# ***Value Engineering Study Report***

## ***SR 8/US 78 at Mann Road/Mason Creek Road and at Post Road Intersection Improvements, Douglas County CSSFT-0008-00(375), PI No. 0008375***

***February 2012***

Subject: Final Value Engineering Study Report  
***SR 8/US 78 at Mann Road/Mason Creek Road and at Post Road  
Intersection Improvements, Douglas County, CSSFT-0008-00(375)  
PI No. 0008375***

## VE ALTERNATIVE A-1

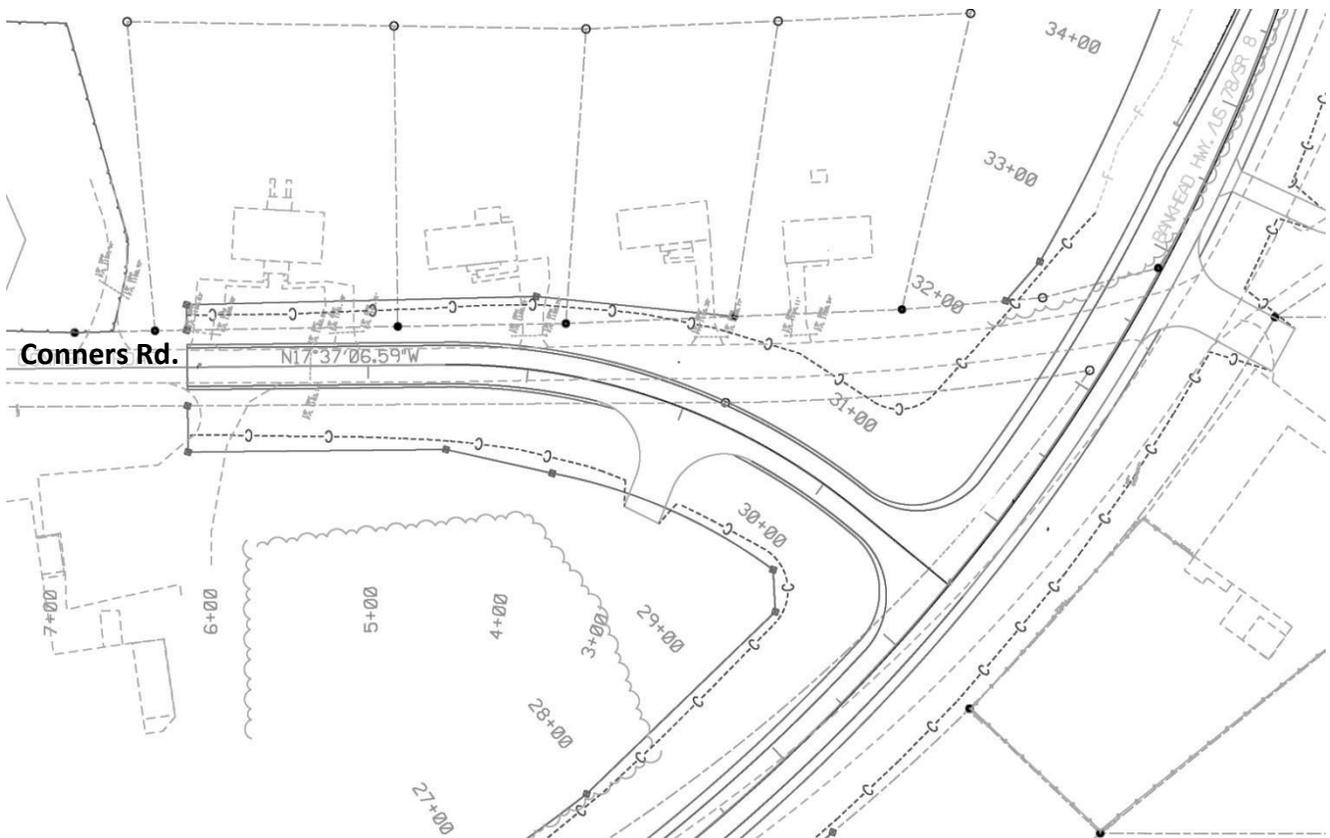
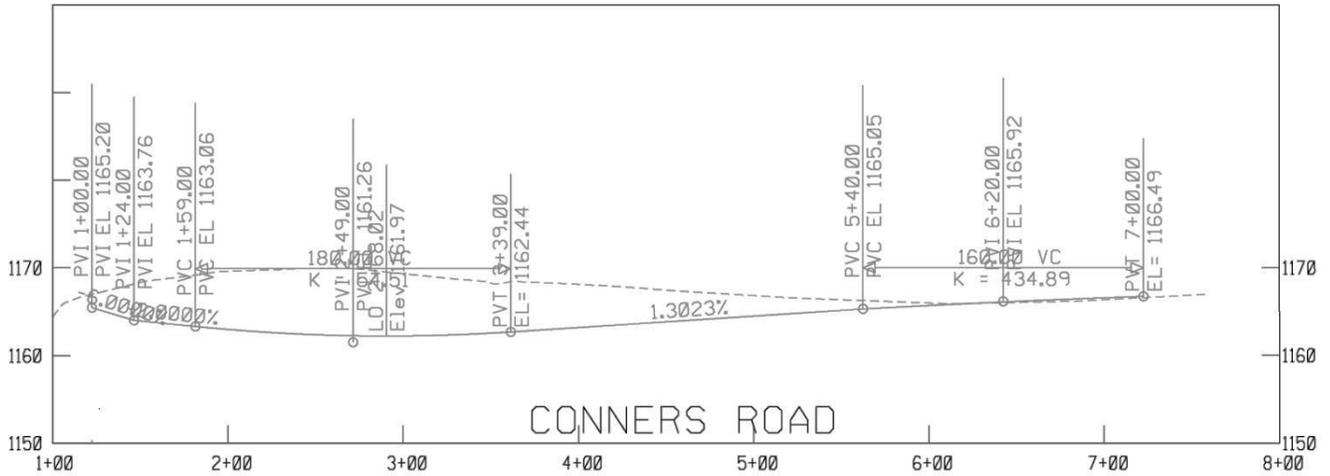
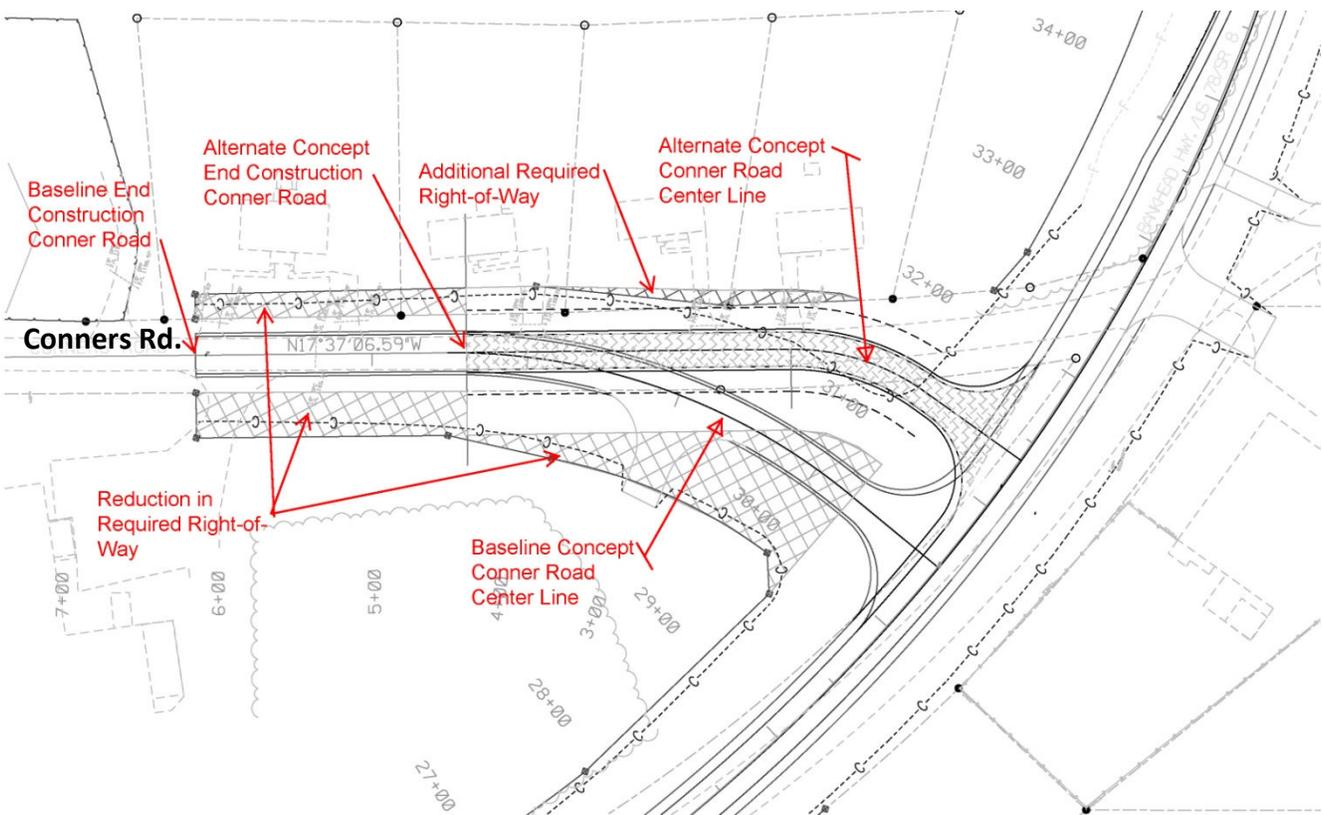
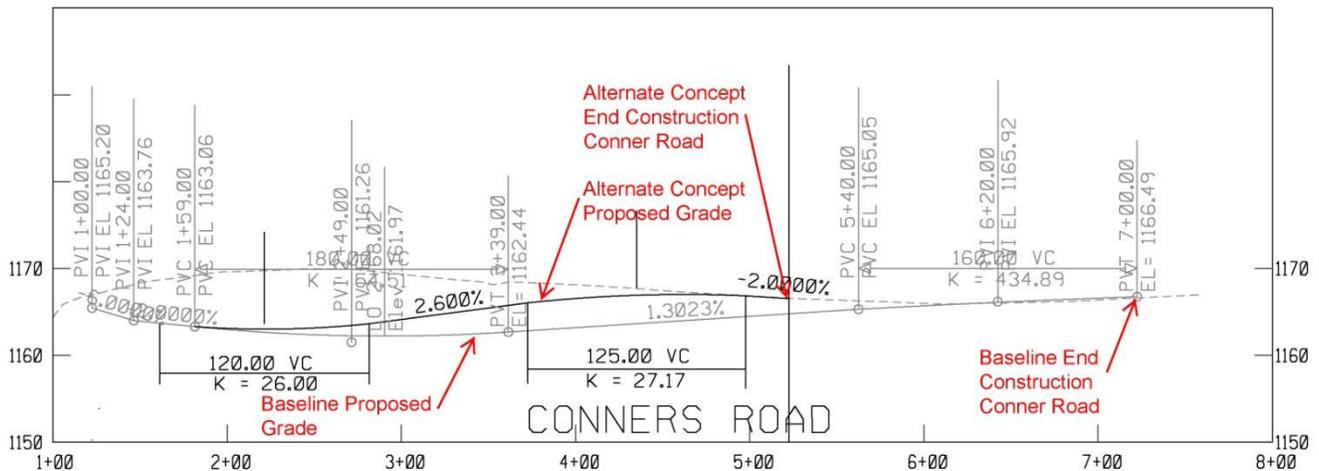
There would be minimal design change to the horizontal and vertical alignments and cross sections, but since the project is in concept phase it does not appear this would affect the current schedule. There would be an approximate 5% reduction in right-of-way acreage to be acquired; therefore, there is a potential for minor time savings during right-of-way acquisition. The construction limits would be shortened by approximately 173 feet, so a minor reduction in construction time along Conner Road may be realized.

Reduce the radius of the horizontal curve at Conners Road from STA 1+00 to 3+00 and revise the profile on the north end to tie into the existing profile sooner

Eliminate the pavement replacement on Mattie McCoy Lane from STA 3+00 to 5+50

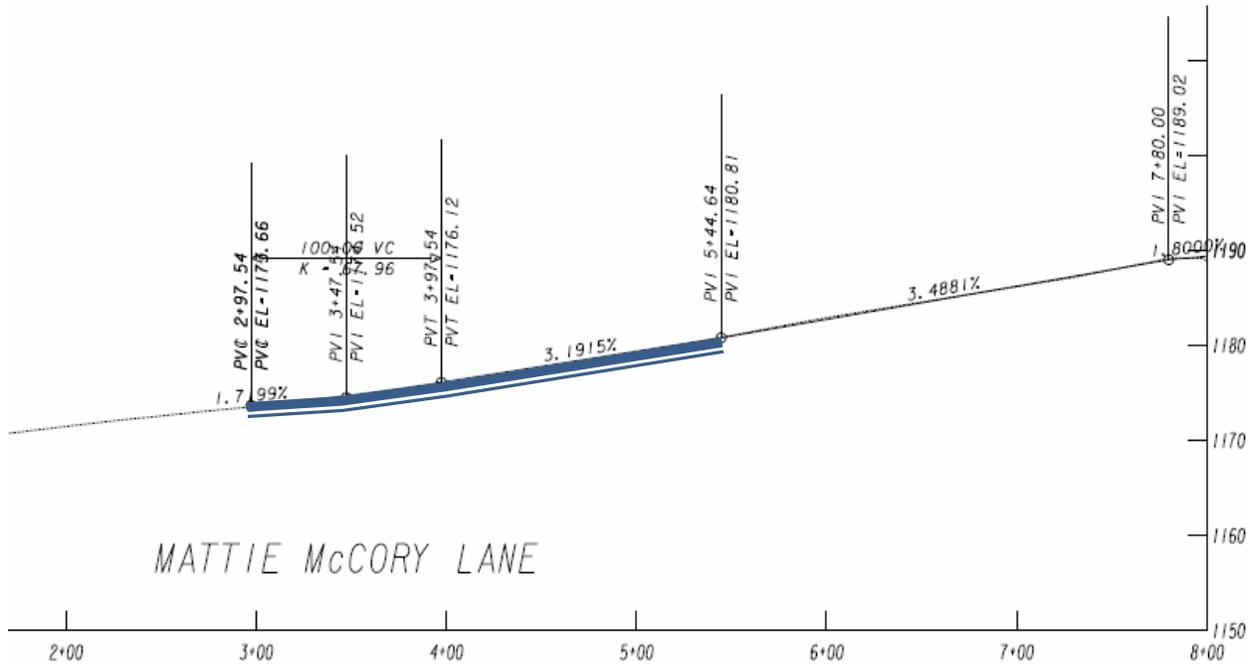
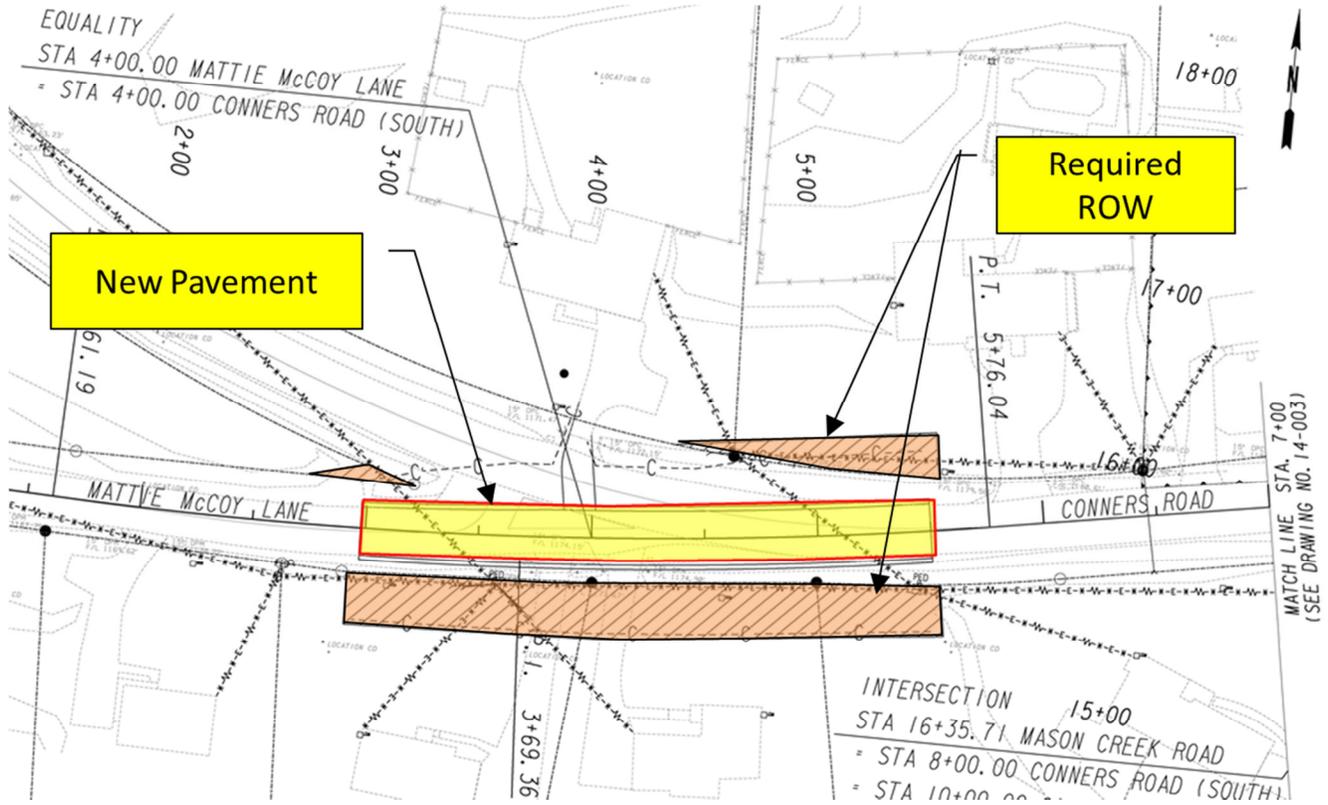
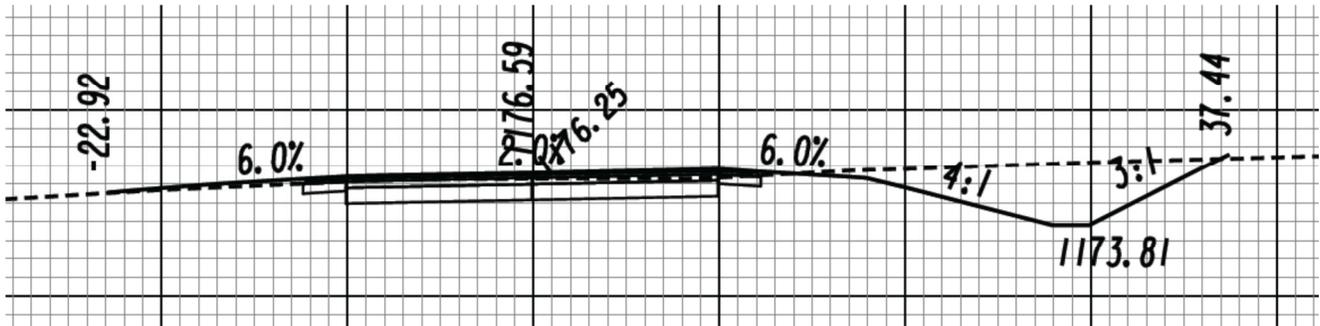
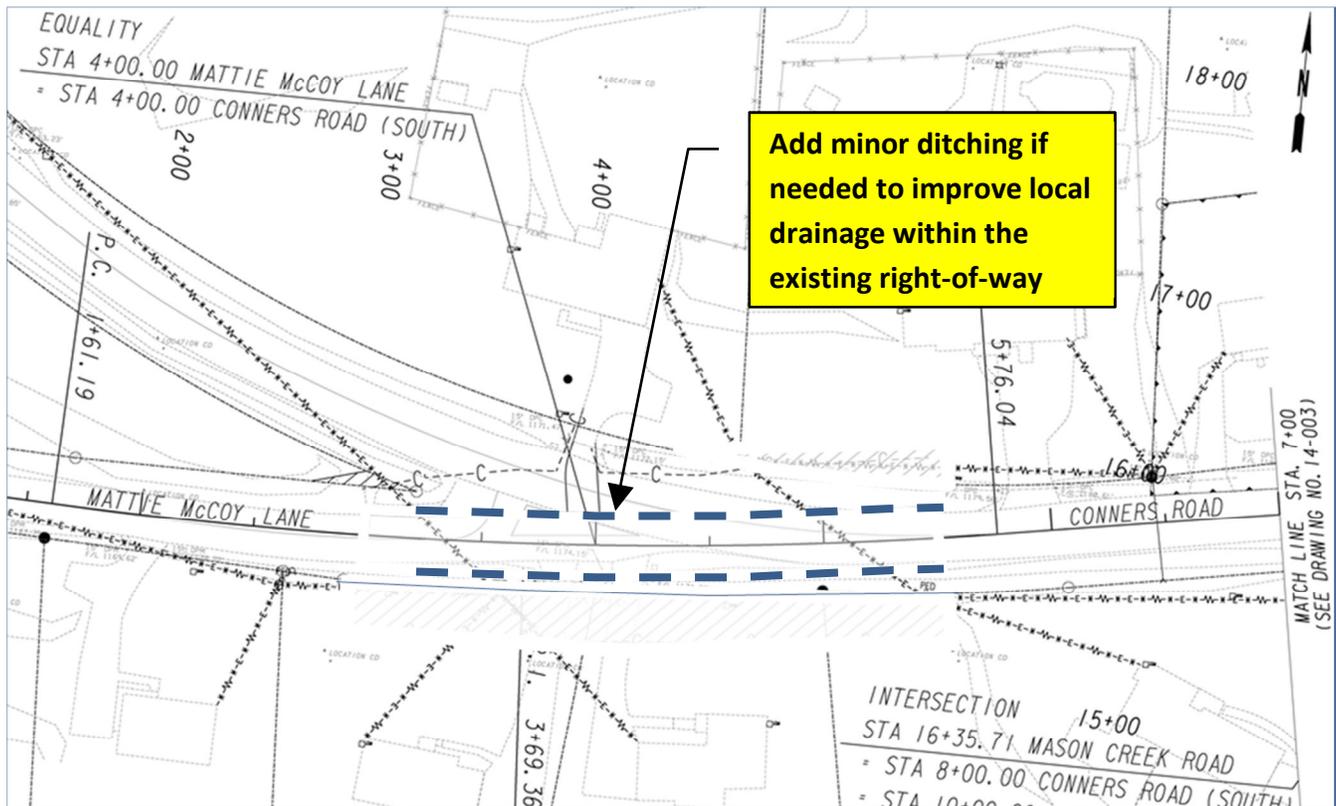
**Discussion:** There does not appear to be an immediate justification for this new pavement along Mattie McCoy Lane. Since the alignment and profile do not change, there is little justification for these improvements. The only improvements needed are some new ditching on Mattie McCoy Lane and possibly guardrail or berm to close off the vacated portion where Conners Road joins Mattie McCoy Lane. These improvements could be done within the existing right-of-way.

There may be public expectations for this portion of Mattie McCoy Lane to be paved, so some investigation is needed to review project notes, commitments, and exhibits which may have been presented in public meetings.

**Description of Alternative Concept:** Eliminate the roadway replacement on Mattie McCoy Lane between STA 3+00 and 5+50 and simply add minor ditching along the north and south side of the existing road as needed.

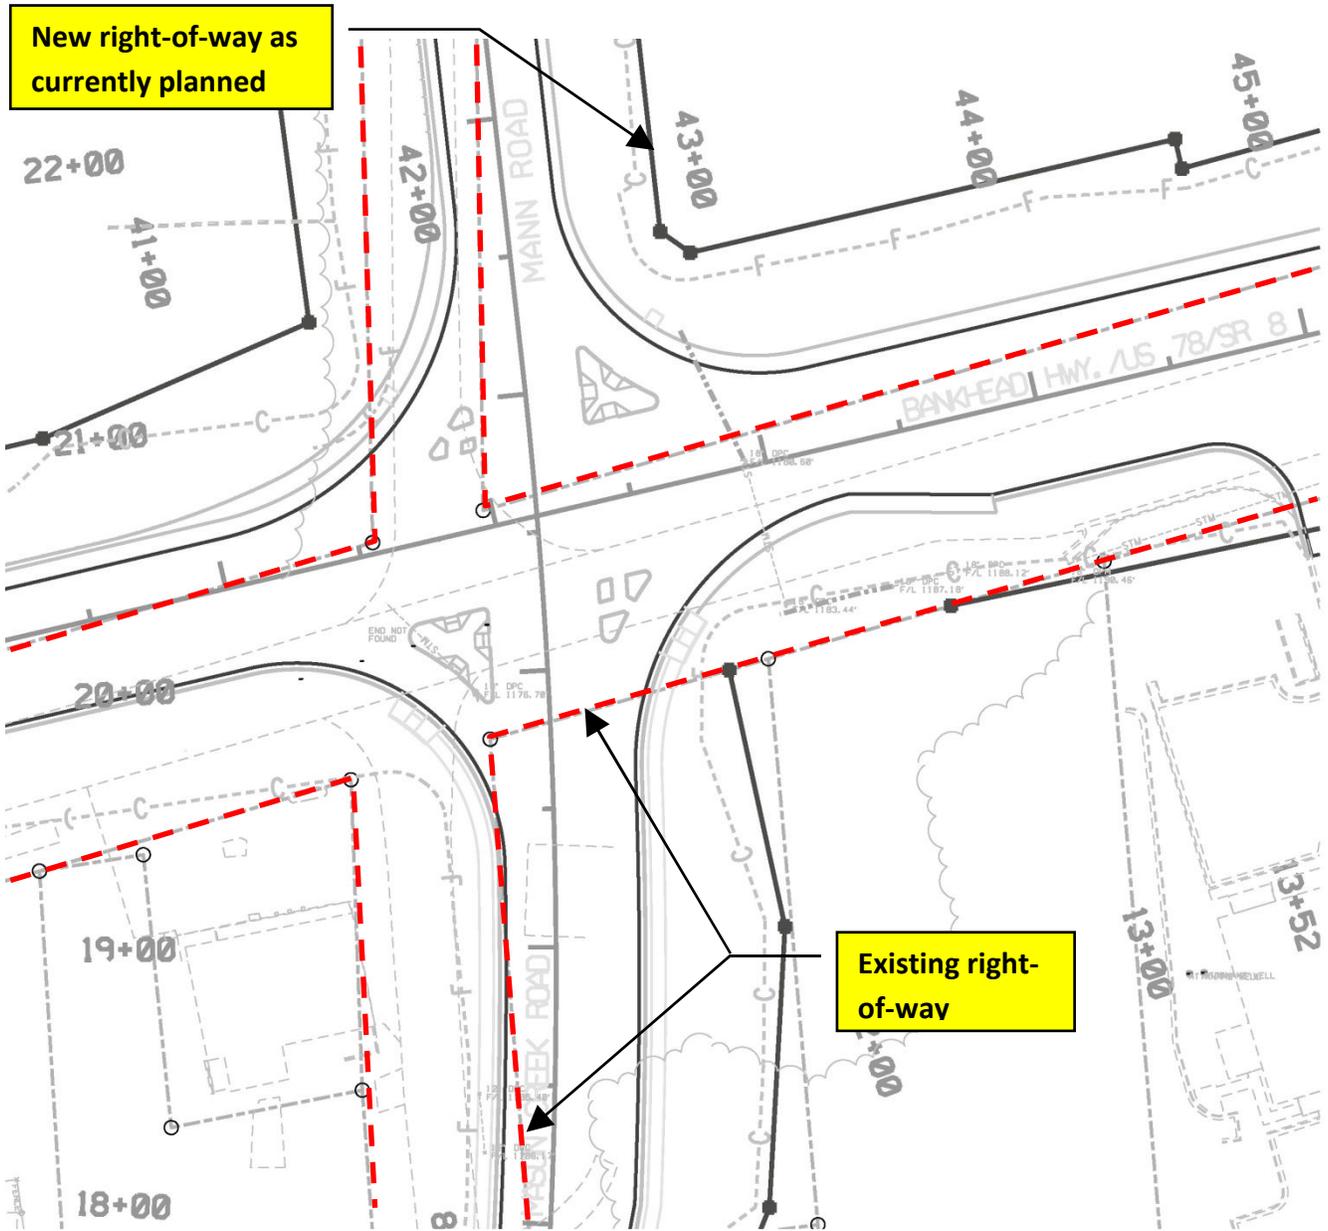
**Discussion:** Since a number of alignment and profile changes may be considered due to reducing the assumed design speed on Bankhead Highway from 55 mph to 45 mph, the crossroads could also be re-evaluated. Since a number of variables are in motion at this time, some re-balancing of the final solution may provide opportunities to control both right-of-way needs and cut/fill quantities. Potential savings may be in the range of \$30,000 – 50,000 depending on the final grade and impact upon adjacent right-of-way. One of the key drivers is the grade difference between the existing road and the proposed profile, and the overall constructibility of the road. If the grade difference can be minimized to less than 2 – 3 feet through modifications to the profile and possibly some use of geotech fabrics to increase the slope on the new fill adjacent to the active roadway, it may be possible to move the alignment to the west.

Revisiting the alignment and profile on Mason Creek Road may add several days of design time, but could result in an optimized project.
